DEVELOPMENT REVIEW BOARD
SUPPLEMENTAL SUBMITTAL

Project Location: Whataburger – Volcano Rd. & 98th St.
DRB Project Number: PR-2019-002402

Bowman Consulting is in receipt of the comments dated January 12, 2022, issued by City of Albuquerque for the Whataburger restaurant at NEC of Volcano Rd. & 98th St, Albuquerque, NM 87121. Please see below for the responses to the comments:

LANDSCAPE PLAN

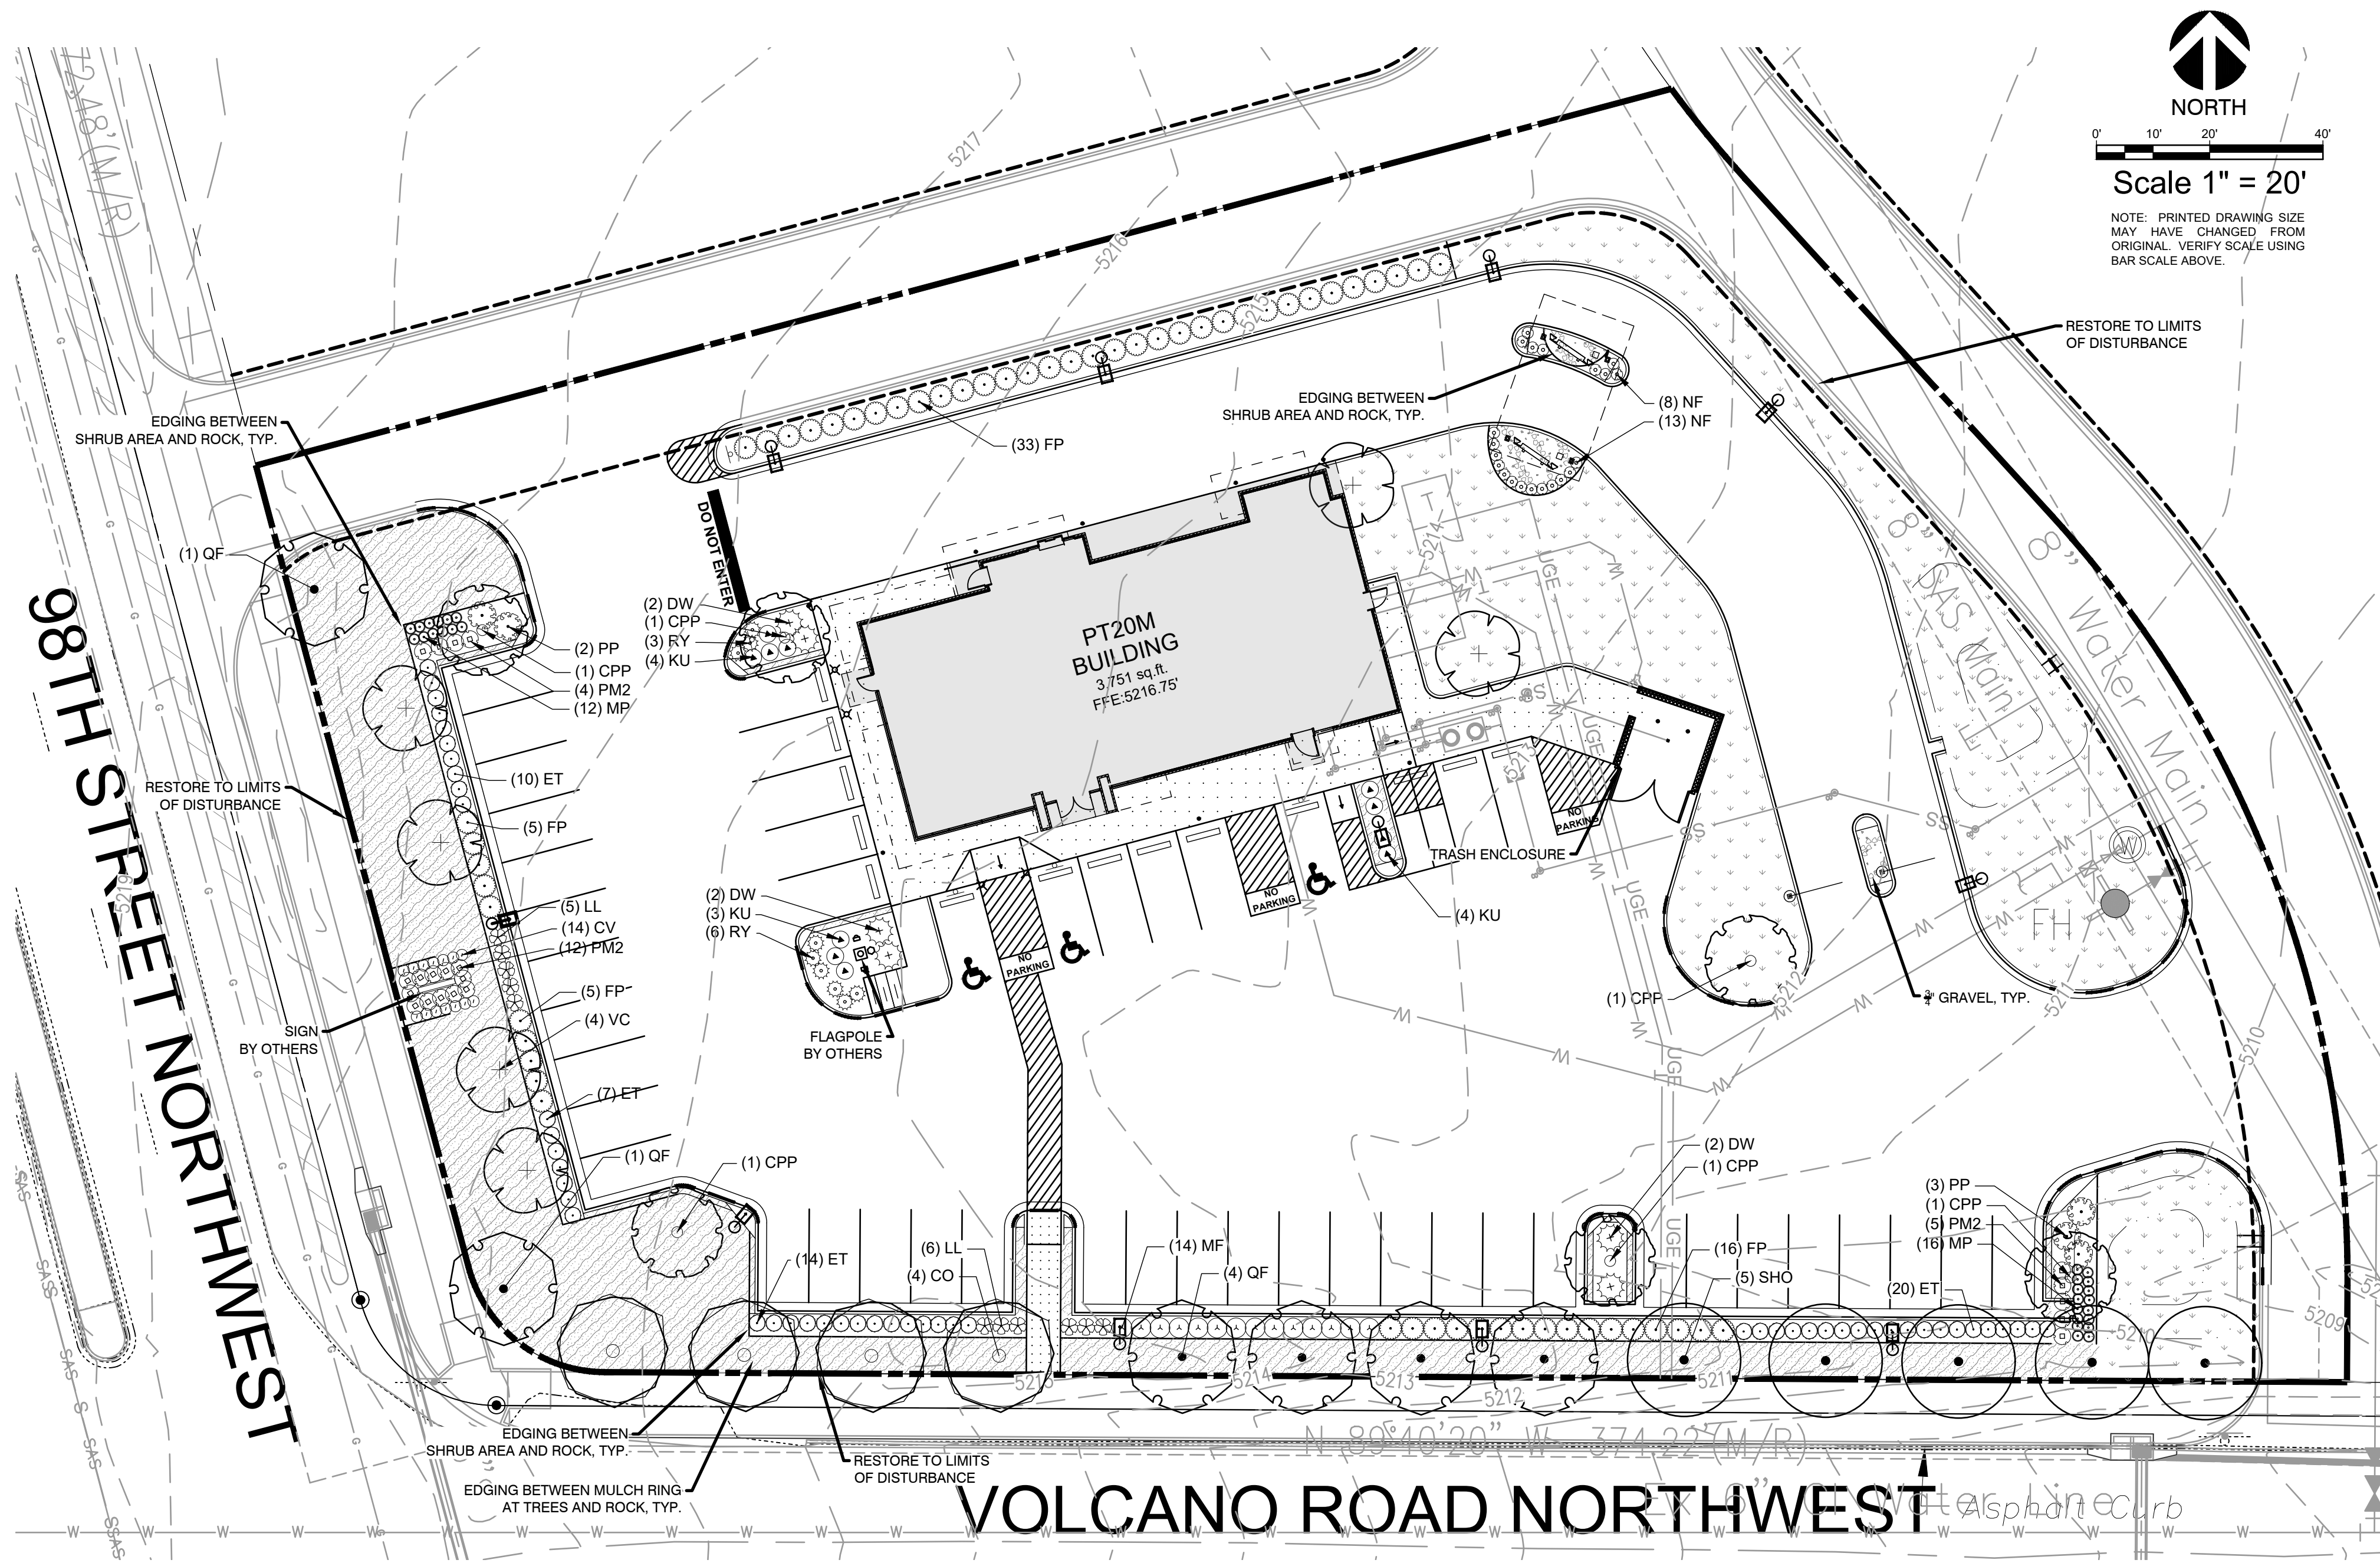
Comment 8: Per 5-2(D) of the IDO regarding design considerations to meet the requirements of site design to respond to climate and geographic features, trees placement is recommended to be in combinations of two-thirds deciduous to one-third evergreen, and trees selection should have three or more tree types to avoid loss of species due to disease. On the Landscape Plan, there is a lack of variation of tree species along the boundaries of the subject property/site fronting 98th Street NW and Volcano Road NW in conflict with the noted design considerations. In addition, the landscaping plan shows one shrub being used all along 98th Street and/or Volcano Road. Please recheck these areas on the landscape plan to verify that the landscaping plan is workable and aesthetically pleasing.

Comment 9: There appears to be a drainage pond in the northeast portion of the site. How will this be landscaped? Some new standards near completion could be applicable.

Comment 10: The Landscape Plan must be sealed and signed by a Landscape Architect registered in the State of New Mexico.

Response: Comment noted. Landscape plan has been revised to be workable and aesthetically pleasing per recommendations.

Response: The two drainage ponds along the eastern drive entrance have been landscaped per City requirements set in the IDO and DPM.

Response: Landscape plan is signed and sealed by Landscape architect registered in the state of New Mexico.
